Discussed basic architecture of the Gaia-wind product(GW133- 11kW turbine), including design of base securing arrangement. Also discussed company findings relating to collapse of GW133 @ Winsdon Farm, North Petherwyn.

I am writing to inform you that I have now concluded my investigation into the Wind Turbine collapse incident, which occurred in early February 2013, involving a Gaia-Wind GW133 11kW Wind Turbine installed at [REDACTED] Devon.

**Design Assessment for the Gaia-Wind 11kW
Wind Turbine**

ES/13/54

Figure 2. Sketch of bottom flange arrangement showing typical fracture location.
C Rudall (Not to scale)

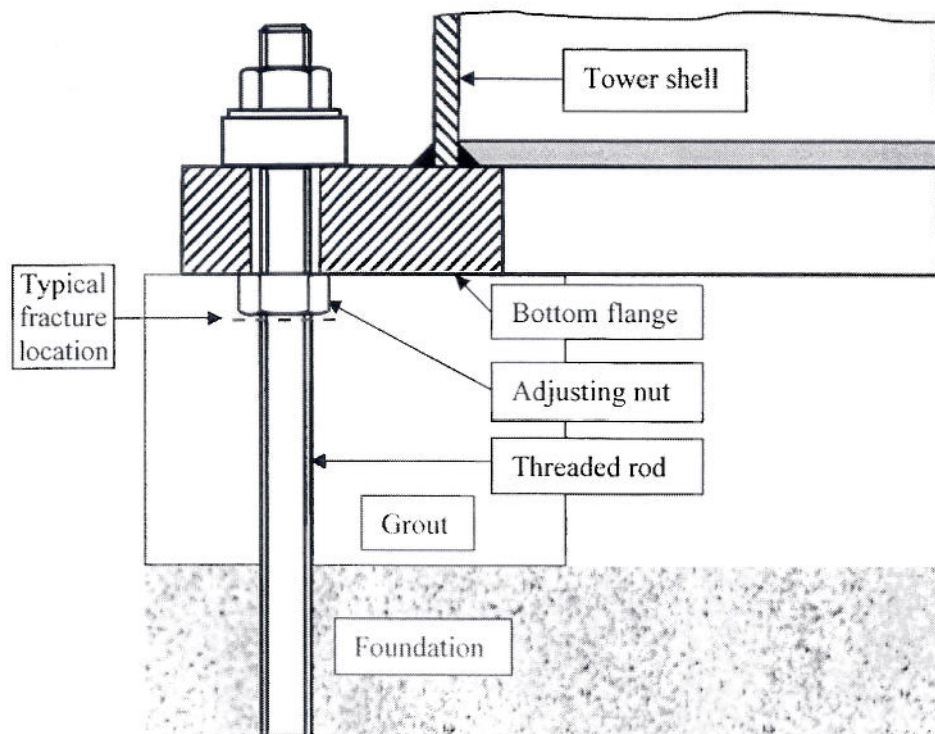
concrete and these are bolted to a flange at the tower base (Figure 2). The tower is levelled by adjusting a nut beneath the flange on each of the threaded rods. As a result of this installation method the threaded rods are not preloaded beneath the levelling nuts. Grout is applied between the flange and the foundation.

The overall conclusion from the metallurgical reports on three sets of failed foundation rods was that failure was due to fatigue. Failure was typically through a horizontal section of the threaded rods immediately beneath the adjusting nuts (Figure 2). A visual inspection on site at the most recent failure (Lindley Hall Farm, Otley) indicated that these rods failed at the same location beneath the adjusting nuts.

Whilst all or some of the above factors may have influenced the failures, in my opinion the main reason for the very poor fatigue performance is the lack of preload in the threaded rods which allowed them to be subjected to cyclic loading. Gaia are aware of this aspect of the design, and comment in their report entitled [REDACTED]

- 1) That Gaia should be encouraged to improve the fatigue design of the tower bottom connection, for example by preloading the threaded foundation rods as described in their report [REDACTED] R12(5)(e)
- 2) That the quality and consistency of the heat treatment and galvanising of the threaded rods should be carefully monitored.

Figure B1. Sketch of bottom flange arrangement.
(Not to scale)

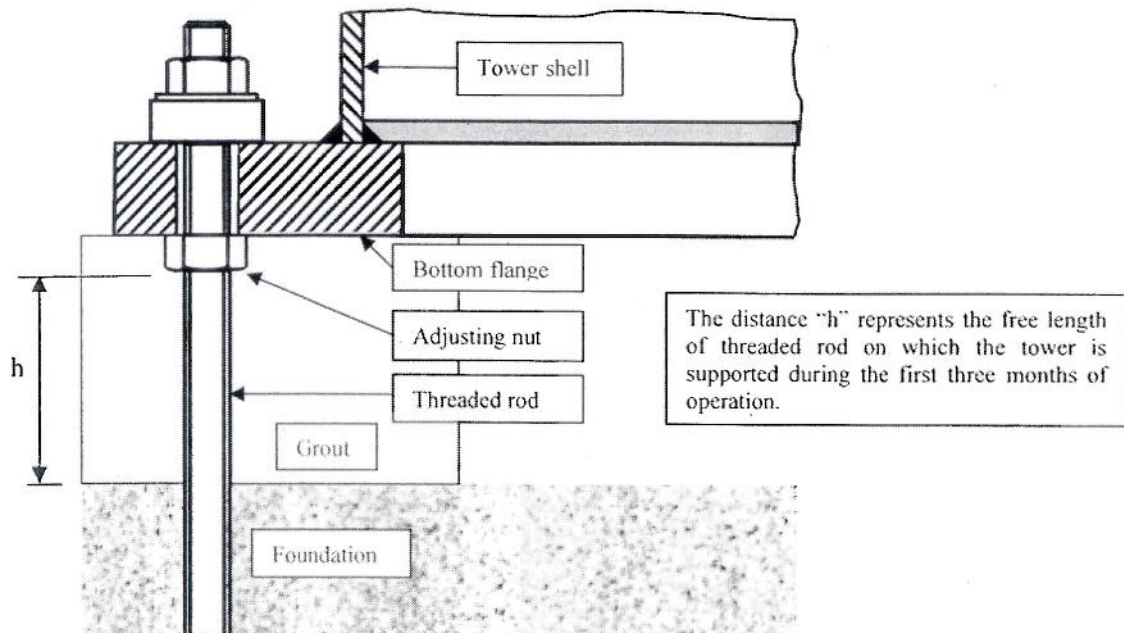
Where h is the unsupported length of rod = 63mm (see Figure B1)
(i.e. based upon a distance of 85 mm beneath the underside of the bottom flange and the top of the foundation, as measured from grout sample 10613 retrieved from the Lindley Hall Farm turbine).

Where h is the unsupported length of rod = 61mm (see Figure B1)

Figure B2
1st generation
rod layout

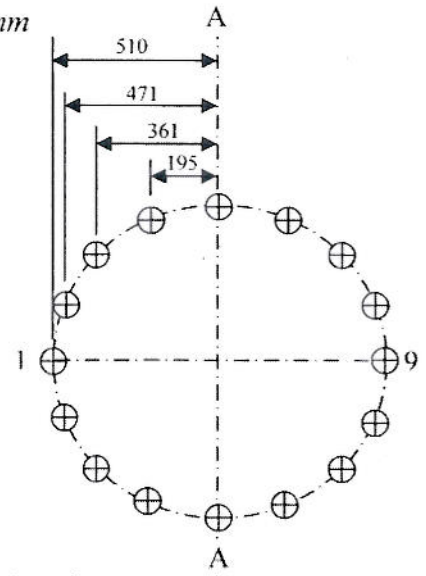
$$F_{1,9} = \frac{M_{tower,max} \times z_{1,9}}{\sum z_n^2} = \frac{379.7 \times 10^6 \times 510}{2.081 \times 10^6} = 93055N$$

Figure B3
2nd generation
rod layout

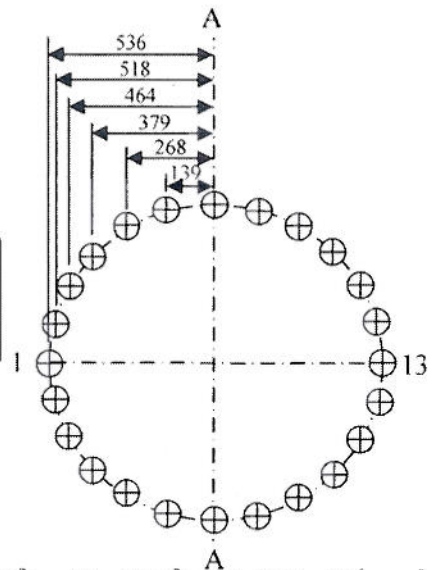
Whilst the 2nd generation tower design is substantially stronger at the base, the foundation rods remain, in my opinion, susceptible to fatigue.

$$\sum z_n^2 = (4 \times 139^2) + (4 \times 268^2) + (4 \times 379^2) + (4 \times 464^2) + (4 \times 518^2) + (2 \times 536^2) = 3.448 \times 10^6 \text{ mm}^2$$
